PACIFIC GAS AND ELECTRIC COMPANY

PGandE Letter No.: DCL-85-210

Re: Docket No. 50-275, OL-DPR-80
Docket No. 50-323, OL-DPR-81
Diablo Canyon Units 1 and 2
Long Term Seismic Program Plan

The NRC Staff's comments on the Diablo Canyon Long Term Seismic Program (LTSP) Plan are grouped below by chapter, numbered, and followed by PGandE's response.

Seismic Reflection Data
for Diablo Canyon
LTSP

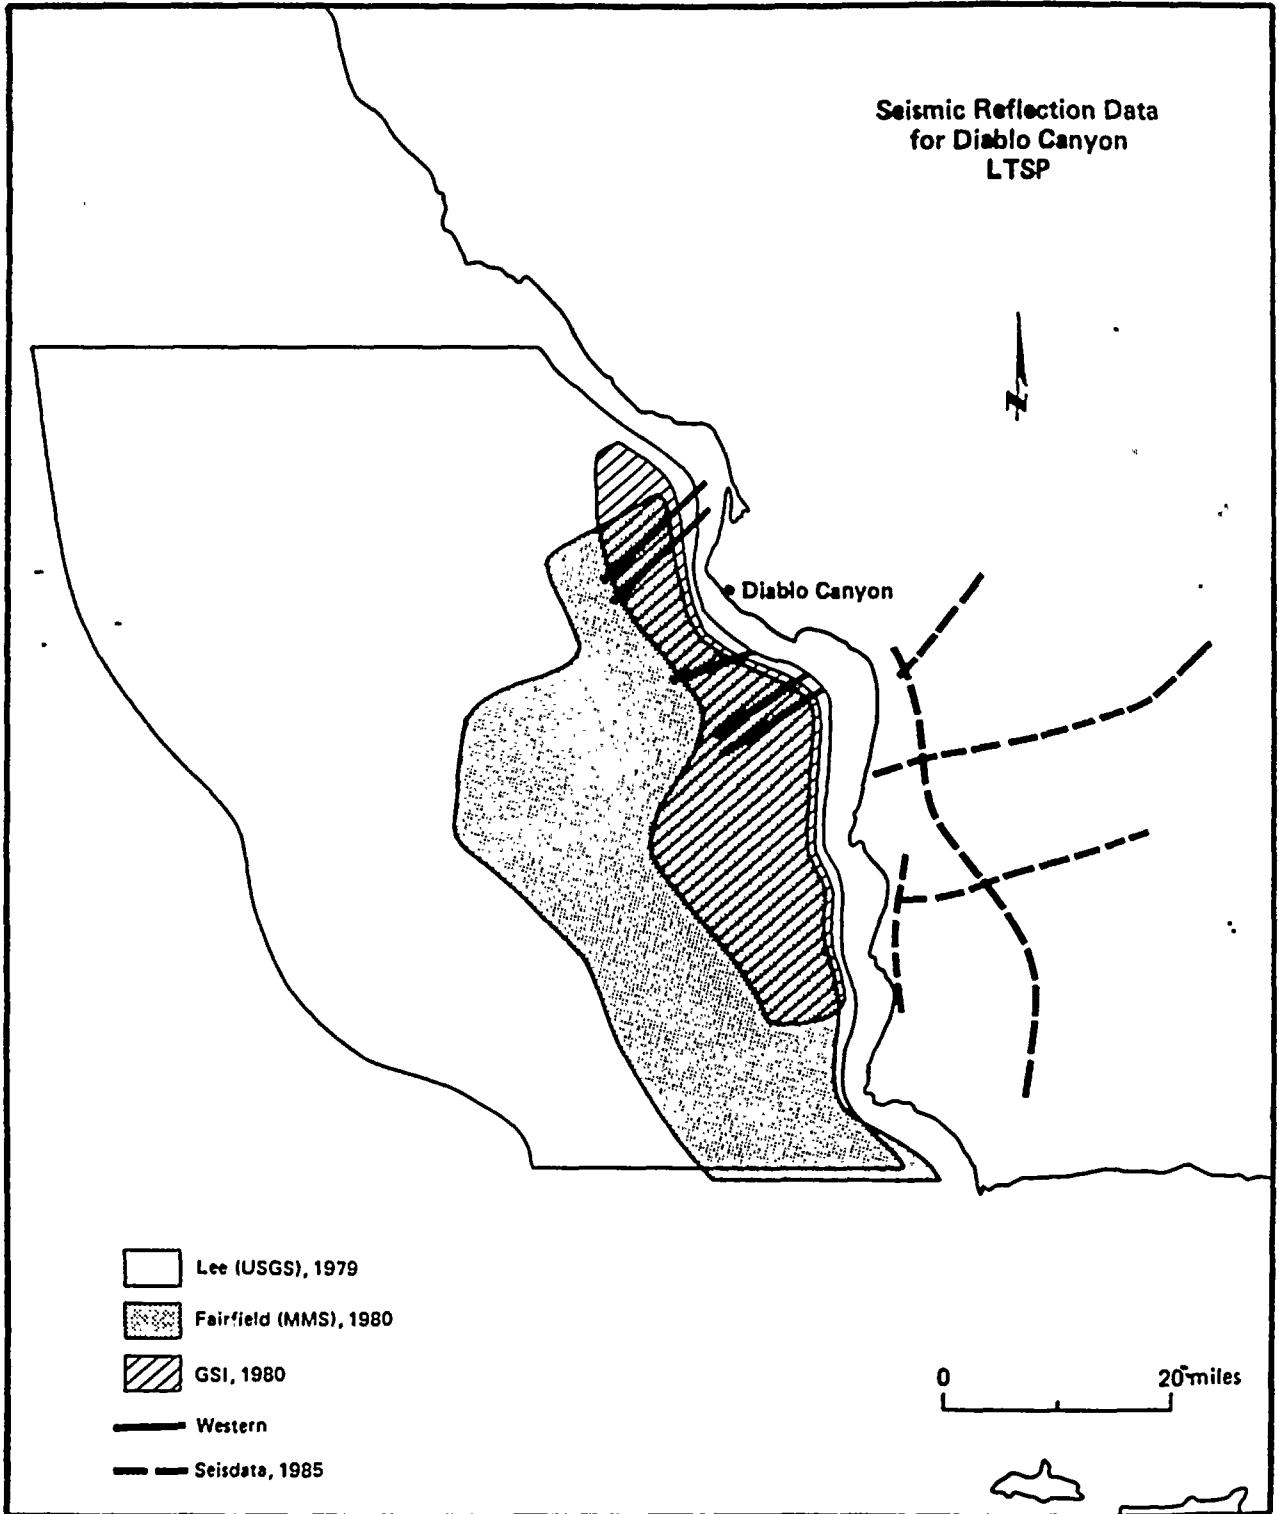
Pages 3-25 and 3-26 (3). At the January 10, 1985 meeting, existing data within the "inner zone" was described. It consisted of deep borings and a grid of seismic reflection lines among other things. It would be useful to the staff and its advisors if this information was identified in the program plan.

Both existing data and data planned for acquisition have been described in the meetings with the NRC Staff in October 1984 and January 1985 and with ACRS in March 1985. A figure prepared for the ACRS meeting (attached hereto) indicated distribution of "Seismic Reflection Data for Diablo Canyon LTSP." Figures presented at the October 1984 meeting with the NRC Staff indicated distribution of existing offshore seismic lines, offshore wells, and onshore wells in the Diablo Canyon local area. Data to be acquired will be identified in a Phase II Scoping Study Progress Report.

SANTA MARIA BASIN REGION

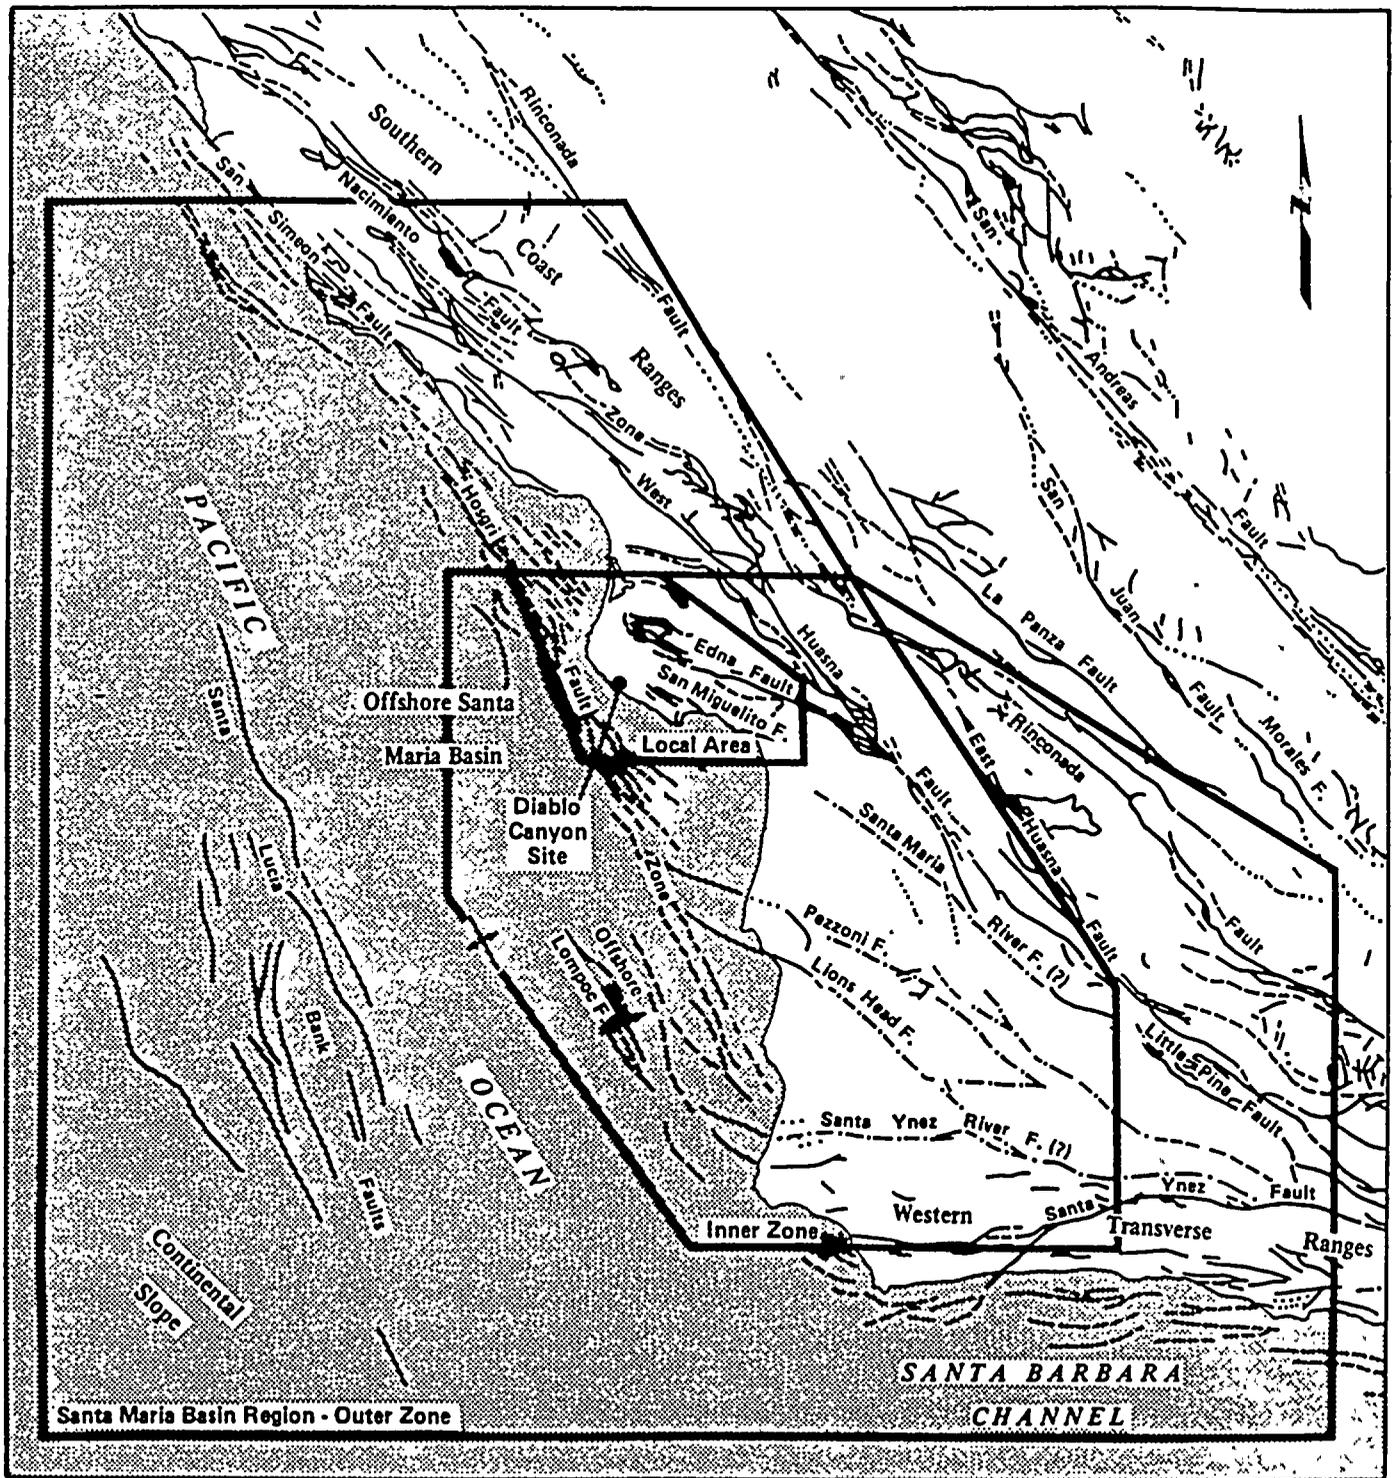
Page 3-16, Figure 3.3-1: The rationale for selecting the irregular shaped areas and the details of what geologic structures are to be included is not clear. The program emphasis on proximity of faults, and on the very long Hosgri fault zone is valid, but the shape of the areas seems arbitrary.

Page 3-16, Figure 3.3-1 shows the line representing the main trace of the Hosgri Fault north of Point Piedras Blancas as swinging to a more northerly strike and joining the San Simeon Fault. Depicting the faults this way indicates a major intersection and continuity between the faults. Does this represent the licensee's interpretation? Will new data be presented to support a major linkage between the Hosgri and San Simeon Faults?

Pages 3-27 and 3-28 (6) and Figure 3.3-1. Should the Outer Zone be extended farther north to include the area where the Hosgri and San Simeon Faults are shown to merge on this figure?

Page 3-37, Section 3.4. The second paragraph discusses the final step in tectonic model evaluation which is to identify local structures that are relevant to assessing the risk of the site. In addition to the Hosgri fault and other large well known structures, two large folds that deform the sea floor within the Santa Maria Basin are mentioned. It would be helpful if these folds were identified and locations shown on a map or figure.

The rationale for selecting study areas shown on Figure 3.3-1 was discussed at the October 1984 meeting with NRC Staff and at the March 1985 meeting with ACRS. The relationship of study area boundaries to tectonic, geographic province, and OCS lease features is shown generally on the figure, "Santa Maria Basin Region," attached hereto. A similar figure was presented at the October meeting. As noted during these presentations, the irregular-shaped areas were selected to correspond to tectonic features at progressively increasing distance from Diablo Canyon except for the west and north boundaries of the Santa Maria Basin, Inner Zone study area, which correspond to OCS Lease Sale 53 boundaries and, therefore, to a region of greater intensity of petroleum industry data and MMS data and hazards studies.

The tectonic features used to define study area boundaries are the following:

- (1) Local Area - west boundary is the western side of the Hosgri fault zone, east boundary is the east side of the Edna fault zone, north and south boundaries are arbitrary lines within Estero Bay and San Luis Obispo Bay, respectively.
- (2) Santa Maria Basin region, inner zone - east boundary is the East Huasna fault, which defines the east limit of most of the onshore Santa Maria Basin Neogene basins; south boundary is the Santa Ynez fault, the major fault along the north side of the Western

Transverse Range structural province, west and north boundaries are tied to OCS Lease Sale 53 boundaries.

- (3) Santa Maria Basin region, outer zone - east boundary is the Rinconada fault, south boundary and west boundary are arbitrary EW and NS lines drawn to encompass the southern part of the Santa Barbara Channel, the continental slope west of the Santa Lucia Bank, and the transitional region between. The outer zone north boundary is an arbitrary EW line that encompasses the region of overlap between the Hosgri and San Simeon faults.

The indicated figure line work was degraded somewhat during printing. The faults do not join in the area north of Point Piedras Blancas but are separated by a thick section of Neogene strata. Fault pattern there is shown in detail on Plate II(N) from FSAR Appendix 2.5E, listed in References, page 3-46. Line work representing the fault pattern north of Point Piedras Blancas is clarified on Figure 3.3-1 (Rev. 1).

As noted in the response to Comment 15 above, the Hosgri and San Simeon faults were not meant to appear to join north of Piedras Blancas Point. The relationship between these faults in this area and elsewhere will be addressed in the San Gregorio-Hosgri fault trend study, identified on page 3-13 and shown on Figure 3.3-1 (Rev. 1).

The location of the two large fold structures is shown on revised Figure 3.3-1 (Rev. 1).
